DATE: March 8, 1999
 PROJ. #: 346462.01
 SUBJECT: Work Plan
 Chevron Station #9-0121
 3026 Lakeshore Ave
 Oakland, California

Subject: Addendum to Work Plan For Monitoring Well Destruction And Installation At Chevron Station #9-0121, 3026 Lakeshore Avenue, Oakland, California.

FIGURE
2

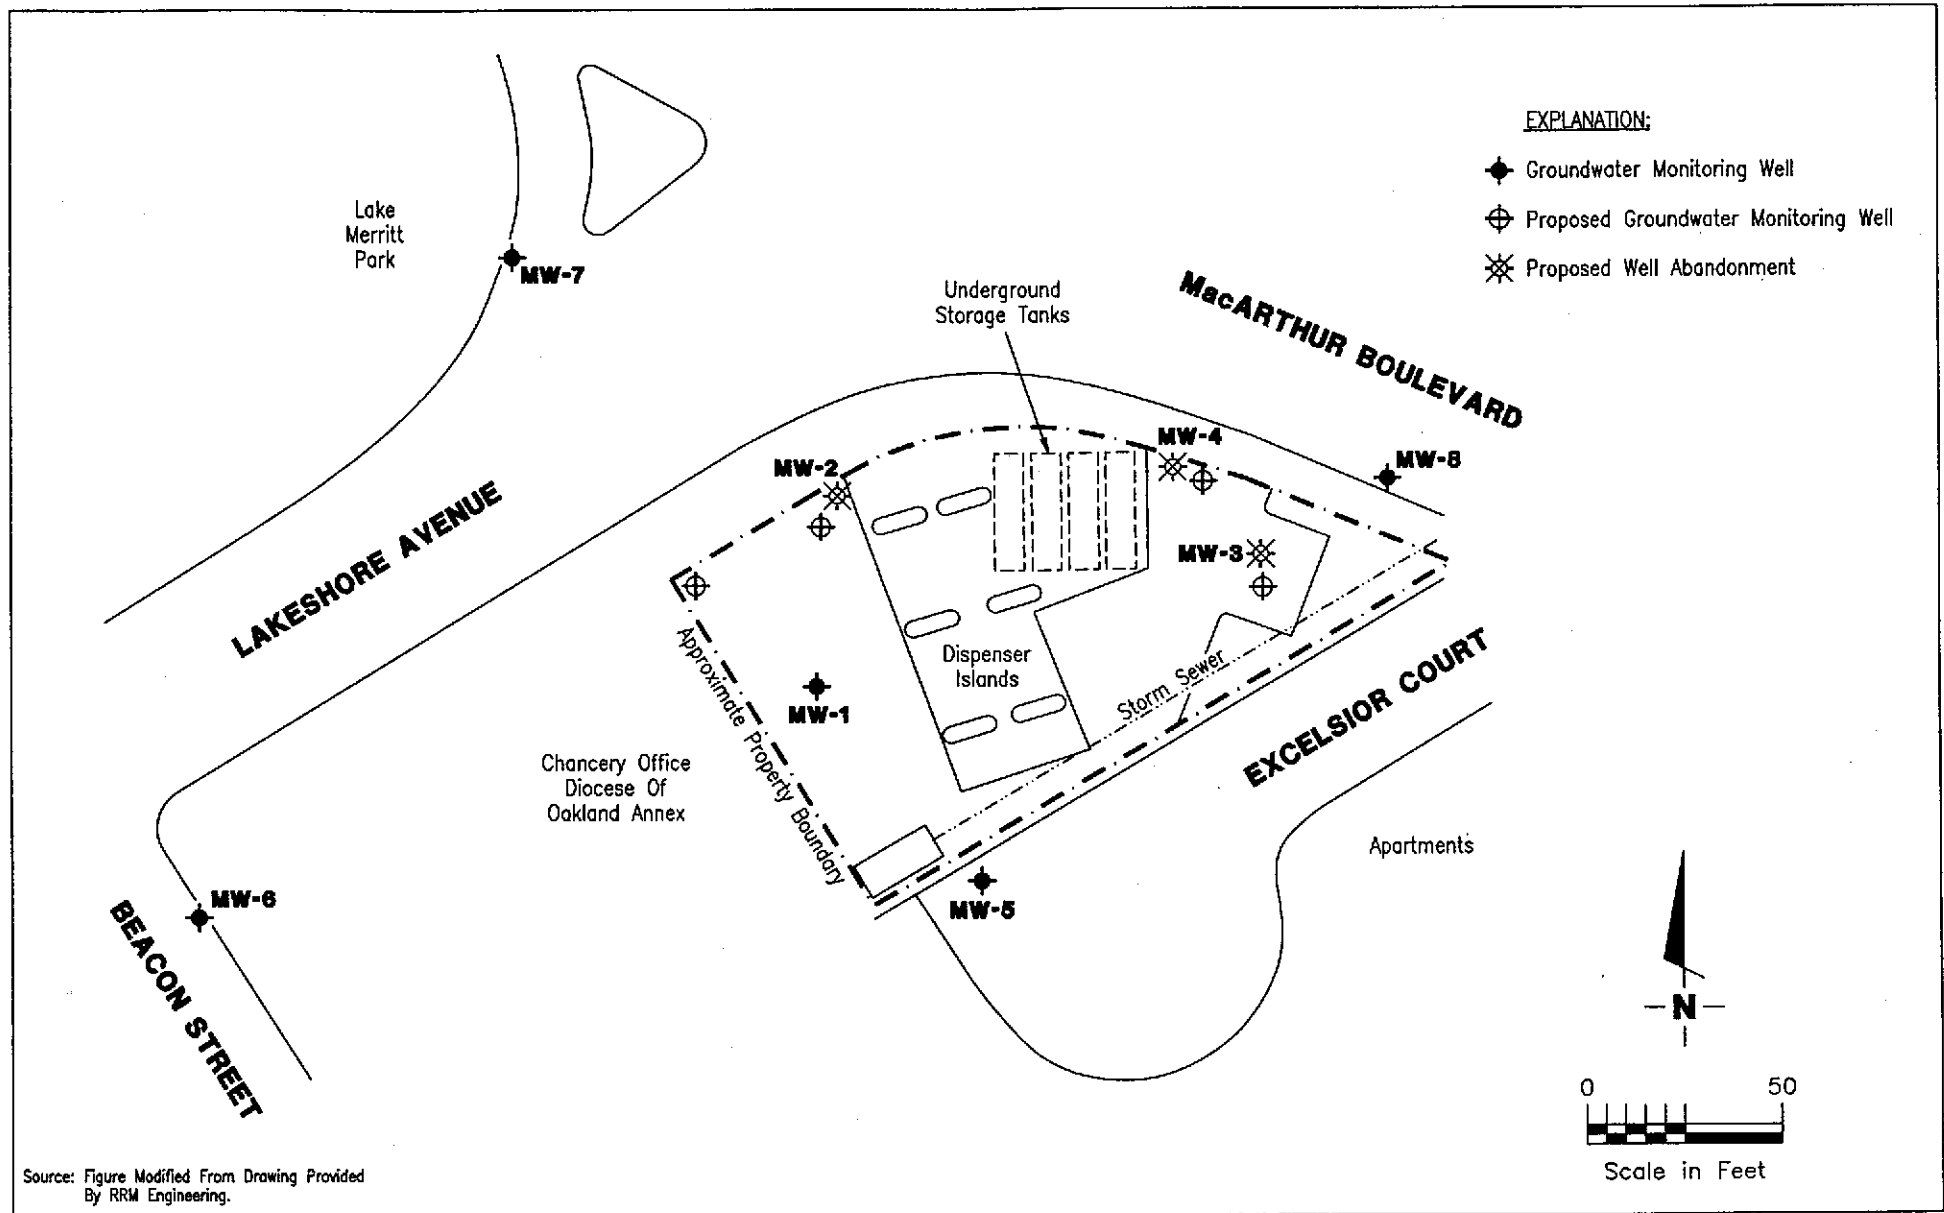
At the request of Chevron Products Company (Chevron), Gettler-Ryan Inc. (GR) has prepared this addendum to Work Plan For Monitoring Well Destruction and Installation at the above referenced site. As discussed in the work plan dated November 17, 1998, GR proposed to destroy three 3/4-inch diameter groundwater monitoring wells (MW-2 through MW-4) and replace these wells with three 2-inch diameter groundwater monitoring wells. Locations of the proposed wells are shown on Figure 2.

The work plan was sent to Alameda County Health Care Services (ACHCS) for approval. The work plan was approved in a letter issued by ACHCS dated February 26, 1999. ACHCS requested that well MW-2 not be destroyed, and that a new well be installed 40 feet downgradient (southwest) of well MW-2. Location of the proposed well (MW-9) downgradient of well MW-2 is shown on Figure 2. Well MW-9 will be constructed as shown on Figure 3. GR Field Methods and Procedures are attached. Per your conversation with ACHCS on March 3, 1999, ACHCS agreed that well MW-2 will be destroyed and replaced as originally proposed.

*3/12/99 Verbal Approval of locations
of wells and replacement of
MW-2 to Stephen at GR*
